# **FIELD REPORT**

INSPECTION DATE: 6/26/23 LOCATION: Wilson Woods Pool ORIGIN: Risk Management

RE: Inspection BY: P. Gionta

### Photos A

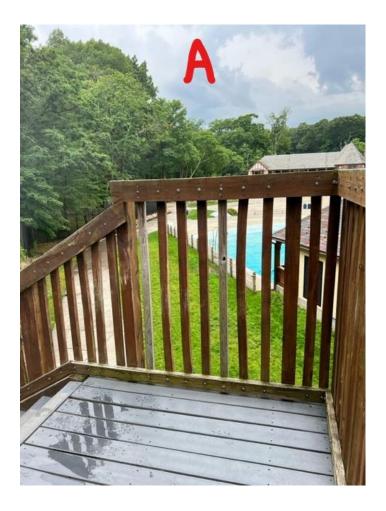
-Photos show the same railing front and back along the stairs up to and including the upper landing. The railing is loose and moves laterally 6-8 inches when handled. Vertical support members on outside are split at the connection hardware.

#### Photo C

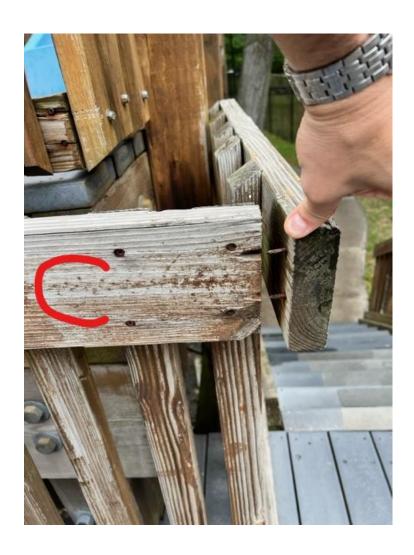
-Pictures show the same joist end to end for the lower landing which is directly below the above pics and makes up the lower landing support. The joist is split lengthwise and is twisting away from the connection hardware.

-Photo shows the right side railing at the lower landing.
